# FTI-TLP4: Vehicle Coverage and Preparation Notes

**Overview:** Mis-Wired door lock connector, field repair required.

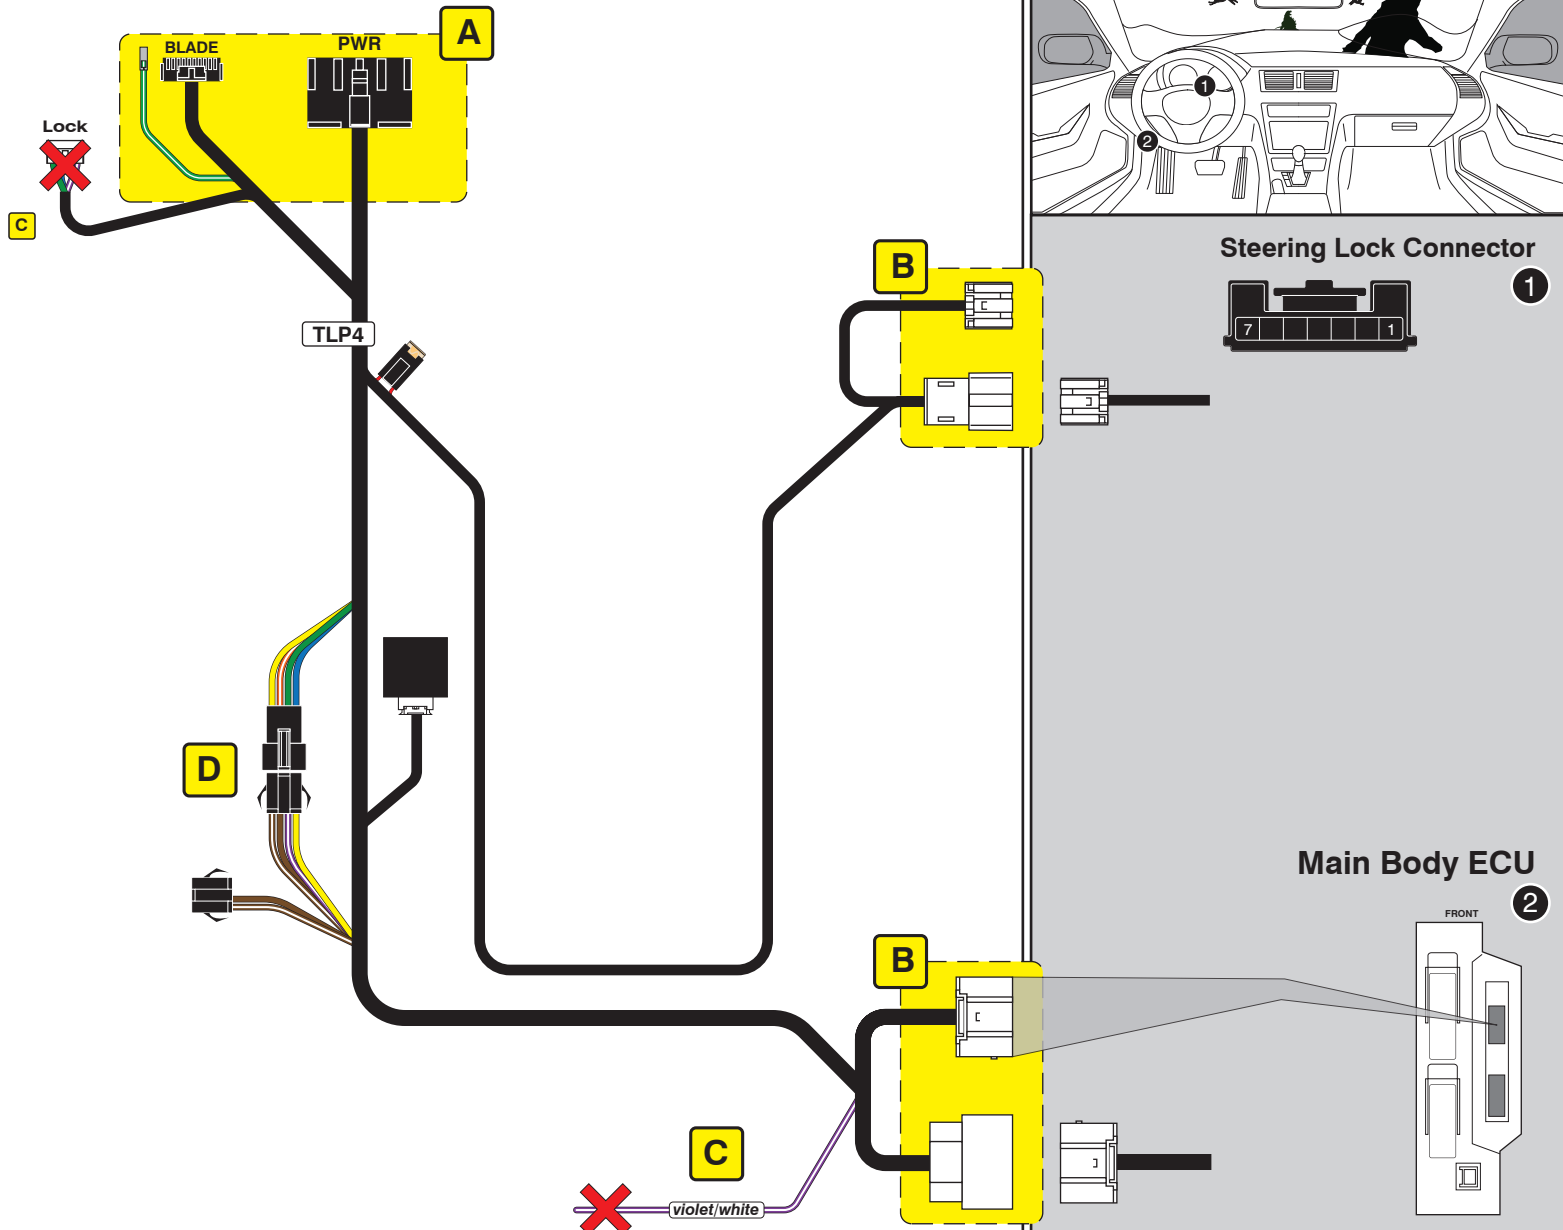
**Issue:** A review of the latest samples of **FTI-TLP4 T-harnesses** has revealed a misplaced trunk output wire in the 6-pin Lock Accessory Connector requiring that the wire be relocated to the correct position, to ensure safe operation when used. **Using the harness without addressing the issue will result in failed trunk/hatch control, and possible damage to the vehicle BCM.**

**Correction:** The harness purple/white wire in the latest production run of FTI-TLP4 harnesses has been inserted in the position normally used for the +12V power connection in the accessory harness. Before completing the installation, the installer must relocate the harness purple/white wire to the correct position, 1 space inward on the 6-pin connector, see illustrations below in Fig. 2.

To relocate the terminal, using a fine pick or Olfa type knife, depress the terminal locking barb and pull the purple/white wire from the connector housing. Once the terminal has been removed from the housing, again using the pick or knife, lift the locking barb about 1/16" (1.5 mm) and reinsert the terminal in the correct position. If upon initial examination of the harness the lock accessory connector looks like the illustration in Fig. 2, no modification is necessary, the wire is in the proper position.
